Shenzhen Merrytek Technology CO., LTD

Class II Permissive Change Letter

FCC ID: 2AI53-MC079DRC2A

Old PCB Top Side MC079D RC2	NEW PCB Top Side MC079D RC2

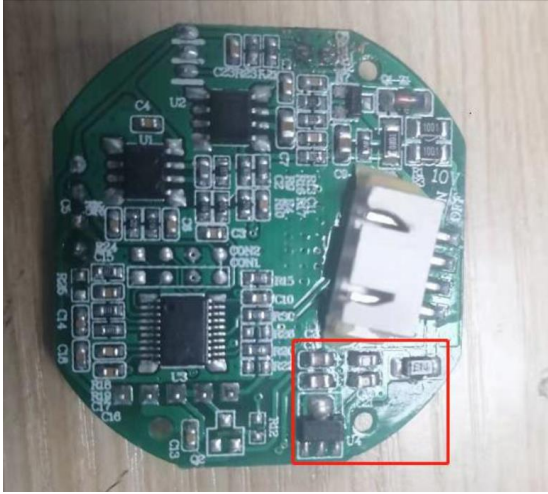
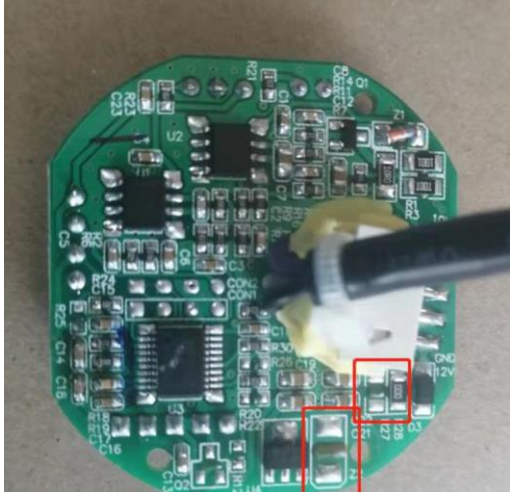
PCB Layout, Antenna Layout and change the location of some components on the PCB there is **Add DC 12V voltage and regulator tube circuit**, Radiated Emission testing was performed to demonstrate RF compliance.
